505-555 South Midvale Boulevard

PLANNING UNIT REPORT
DEPARTMENT OF PLANNING AND DEVELOPMENT
June 14, 2006

**ZONING MAP AMENDMENT TO REZONE 505-550 SOUTH MIDVALE BOULEVARD
INCLUDING A DEMOLITION PERMIT:**

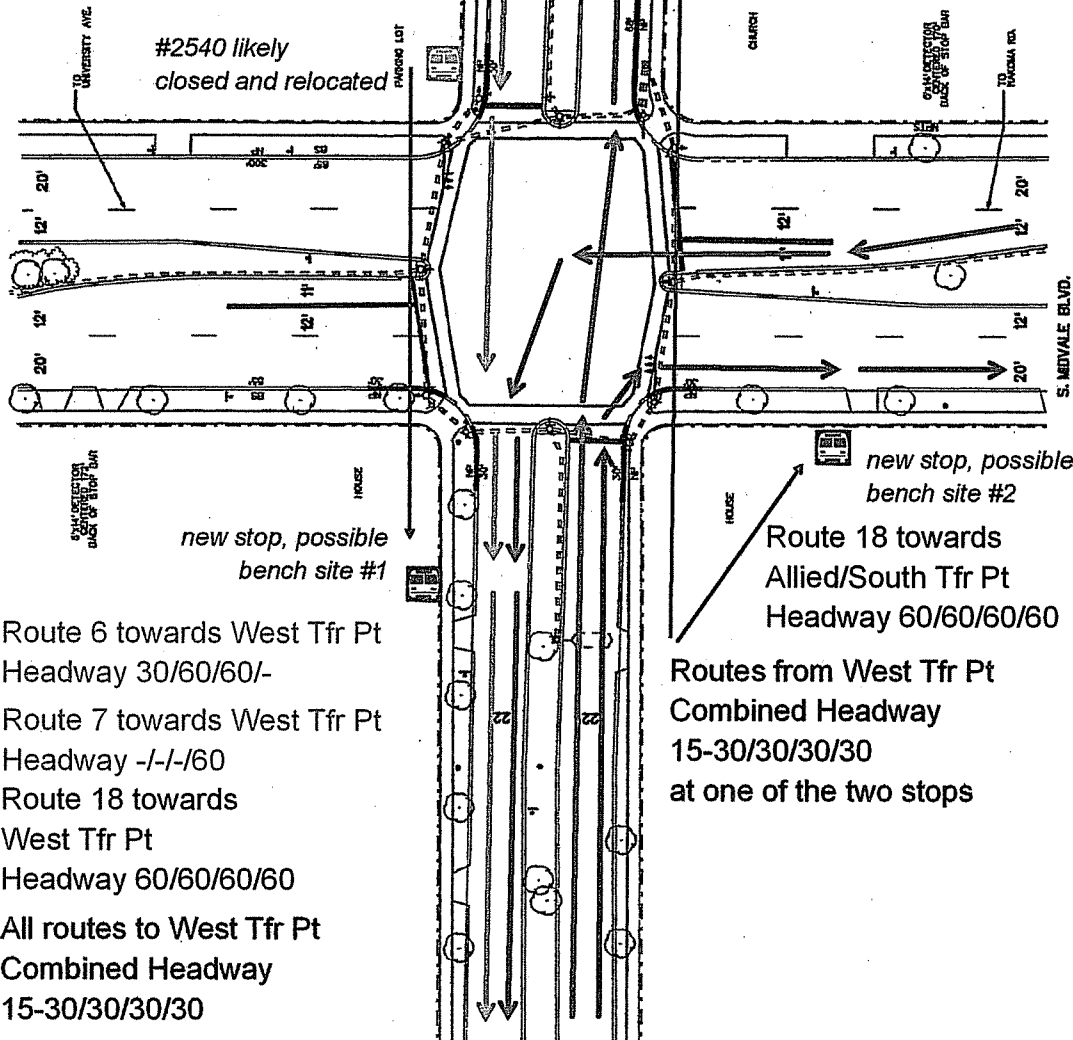
Route 7 towards West Tfr Pt
Headway -/-/60

#2540 likely
closed and relocated

#2111 has shelter
no changes

Route 6 towards downtown
Headway 30/60/60/-
